HISTORIC DISTRICT COMMISSION

MEMORANDUM

RE: Historic District Permit Application, Patrick Murphy on behalf of Aaron and Monica Pokorny: 254 Francis

REQUEST: The applicant proposes to construct a new dwelling on a lot at 254 Francis Street. The corner lot is zoned Community Residential- R-1 and has 84.63 feet of frontage on Holland Street and 95.20 feet on Francis Street. The lot is 8,712 square feet in size.

drawing number:

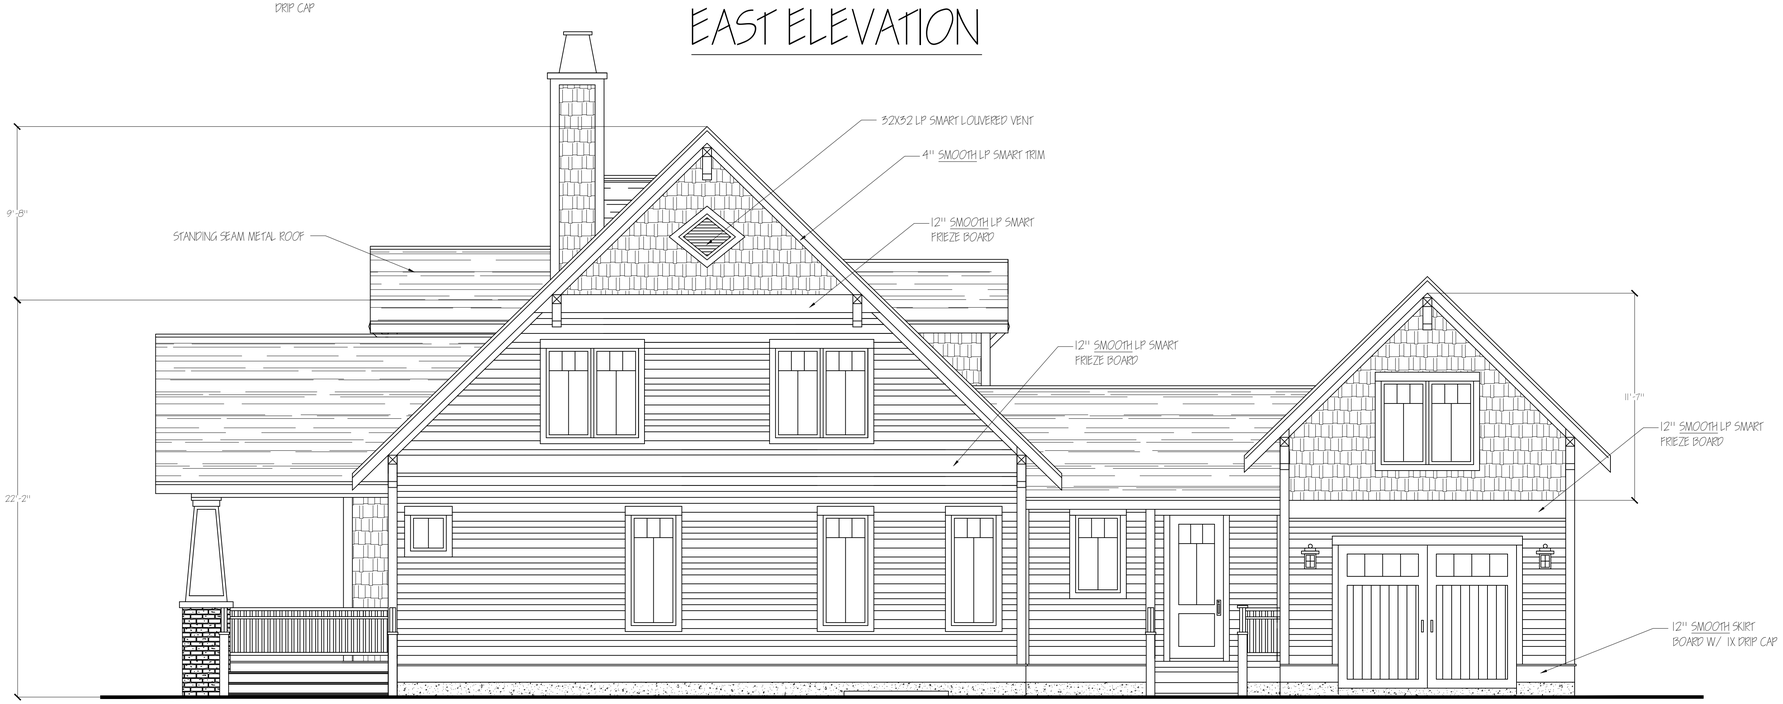
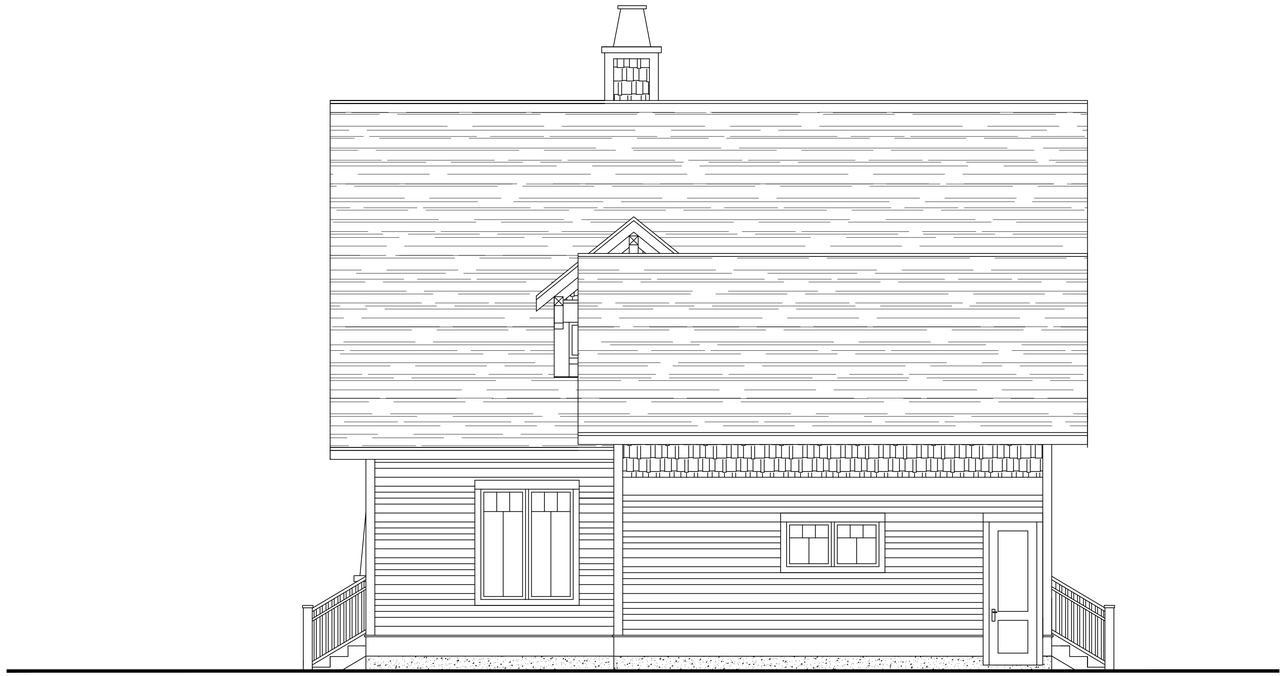
The new 3D renderings show shingles over the entire structure with no metal roofing. The architectural plans appear to be revised to show shingles, but the standing seam metal roof note remains. The applicant should address this inconsistency.

The applicant addressed the previous concerns with massing, scale, and building height by lowering the first-floor elevation by approximately two feet. As such, the staircases are lower, and the basement windows (in wells) are no longer visible.
